## Product / Process Change Notification (PCN)

**PCN #:** PCN\_WCAP-PHLE\_20210614

**Affected Series:** WCAP-PHLE

Due to database mismatches, Würth Elektronik is going to correct the datasheets of the product series WCAP-PHLE.

**Packaging Specification - Tape and Reel: [mm]**

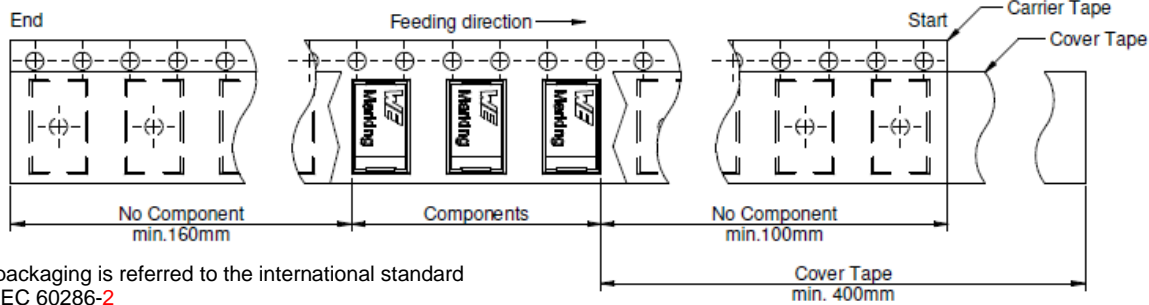
- Würth Elektronik corrects the tape packaging specification for all products of WCAP-PHLE:

**Before correction:**

After change:  
This will be deleted

packaging is referred to the international standard IEC 60286-2

packaging is referred to the international standard IEC 60286-3

Tape Type	A0 (mm)	B0 (mm)	W (mm)	T (mm)	T1 (mm)	T2 (mm)	K0 (mm)
	typ.	typ.	+0,3/ -0,1	typ.	typ.	typ.	typ.
2a	4,50	7,60	12,00	0,30	0,05	2,55	2,40

P0 (mm)	P1 (mm)	P2 (mm)	D0 (mm)	E1 (mm)	E2 (mm)	F (mm)	Material	Qty. (pcs.)
±0,1	±0,1	±0,05	+0,1/ -0,0	±0,1	min.	±0,05		
4,00	8,00	2,00	1,50	1,75	10,25	5,50	Polystyrene	3500

Specification after correction:

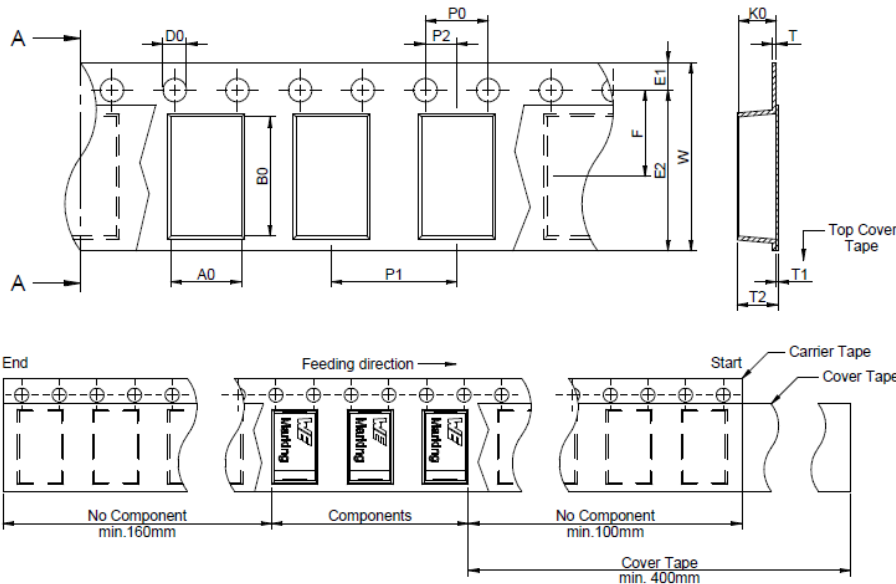
After correction:

**Before correction:**

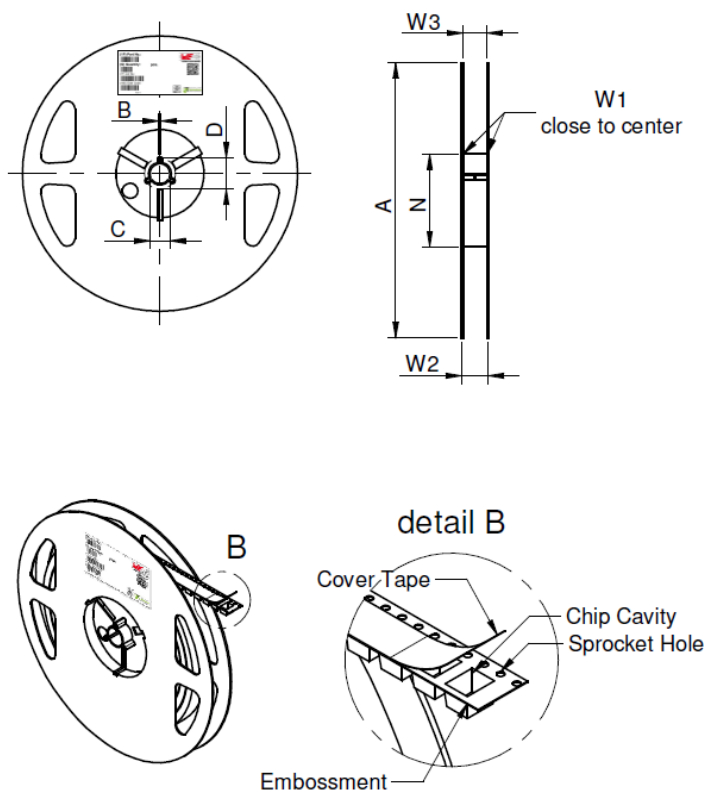
- Würth Elektronik corrects the reel packaging specification for all products of WCAP-PHLE:

A (mm)	B (mm)	C (mm)	D (mm)	N (mm)	W1 (mm)	W2 (mm)	W3 (mm)	W3 (mm)	Material
± 2,0	min.	min.	min.	min.	+ 2,0	max.	min.	max.	
330,00	1,50	12,80	20,20	60,00	12,40	18,40	11,90	15,40	Polystyrene/ Polyurethane

A (mm)	B (mm)	C (mm)	D (mm)	N (mm)	W1 (mm)	W2 (mm)	W3 (mm)	W3 (mm)	Material
Tol.	± 2,0	min.	min.	min.	typ.	+ 2,0	max.	min.	max.	
Value	330,0 0	1,50	12,80	20,20	80,00	12,40	18,40	11,90	15,40	Poly-styrene
